Interactive comment on “Groundwater level changes on Jeju Island associated with the Kumamoto and Gyeongju earthquakes” by Soo-Hyoung Lee et al.

Received and published: 12 May 2017

Fig. 1. RC1_reply_(1) question (Fig. 2)

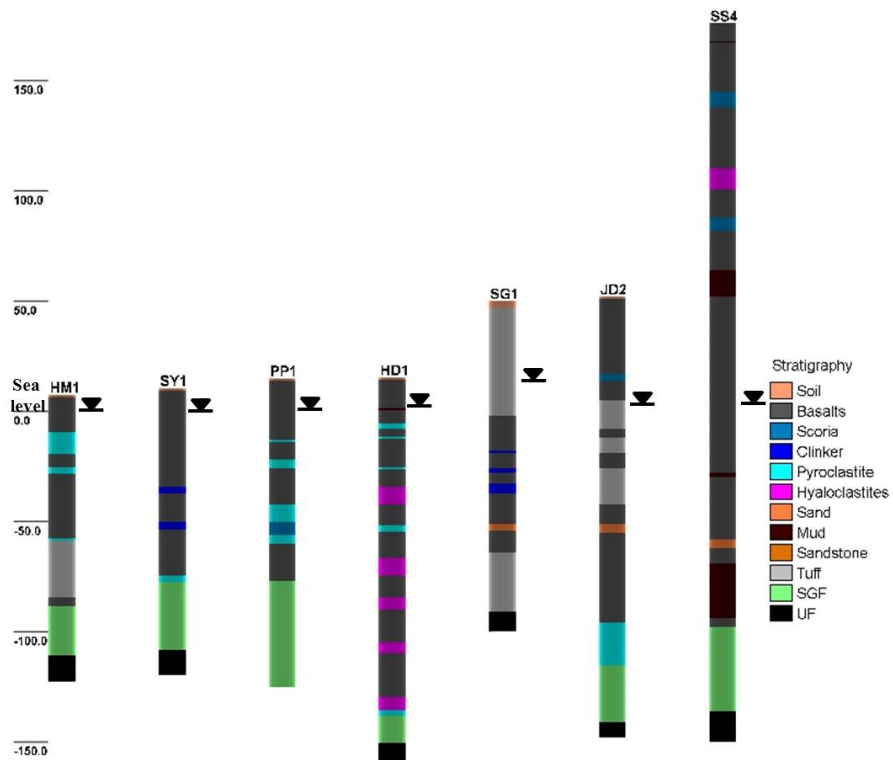
(1) The authors described the lithology and groundwater wells in Jeju Island, but no information is provided about aquifer and the well structure of these wells. I suggest that a cross-section of the hydrogeology setting with location of these wells would be insightful.

1) Reply - We agree with your comments. Accordingly, we added Fig. 2 (Geologic logs of the monitoring wells). As described in the revised manuscript (the lines 4 - 9 on the page 3), based on the geological logs of the monitoring wells that are mostly drilled to UF (Unconsolidated Formation), porous lava flows of repeatedly accumulated layers cover the basement rocks. Especially, in the higher altitude area, more abundant lava flows appear with the existence of many volcanic units (including clinker, scoria, sediments, pyroclastites, and hyaloclastites etc.) between the lava flows. Consequently, groundwater moves along complicated flow paths under the influence of numerous hydraulic parameters. (See the figure below)

Fig. 2. RC1_reply_(2) question

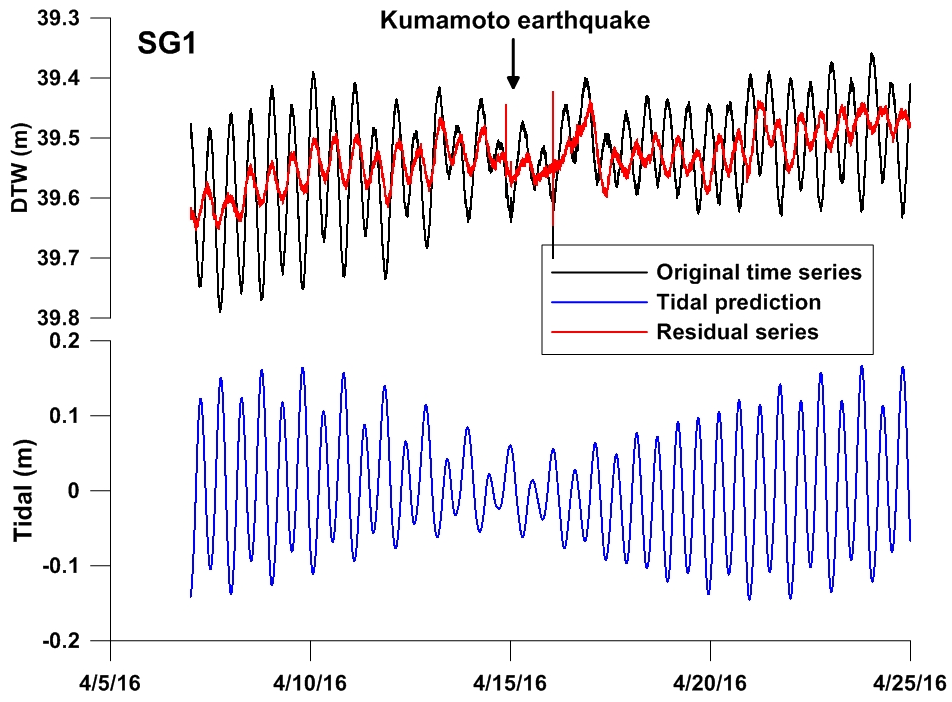
(2) Equation 1, the authors use the moving average method to filter the relative low frequency ocean tide. However, in my understanding, the ocean tide has different frequencies (ranges from low to high frequencies). What's more, I think if you want to filter the low frequency signals, why don't you use the high-pass filtering? I am doubting about the result by moving average method in filtering the low frequency data. The ocean tide can be calculated and removed by several existed programs such as Spotl, Baytap.

2) Reply - We agree with your comments. Tidal effect was eliminated from the measured groundwater level time series, by considering ocean tidal prediction and using T_TIDE MATLAB code (Pawlowicz et al., 2002) that was available from the server (<http://www.iamg.org/CG-Editor/index.htm> or <http://www.ocgy.ubc.ca/~rich>). (See the figure below).

Fig. 3. RC1_reply_(3) question (Fig. 5)

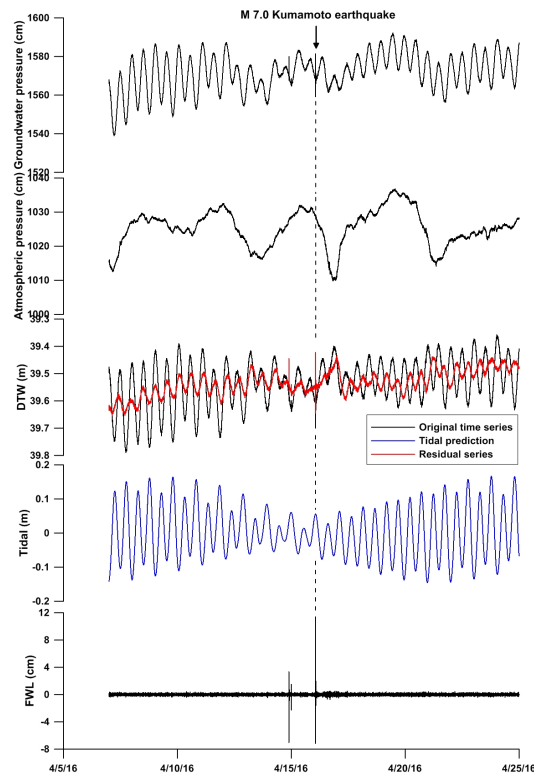
(5) The author said X_t is the raw groundwater level corrected for atmospheric pressure, but they didn't show what method was used in the correction.

5) Reply - The raw groundwater level was corrected for barometric pressure effect, by simultaneous atmospheric pressure measurement with the groundwater level measurement. Please refer Fig. 3. (See the figure below).
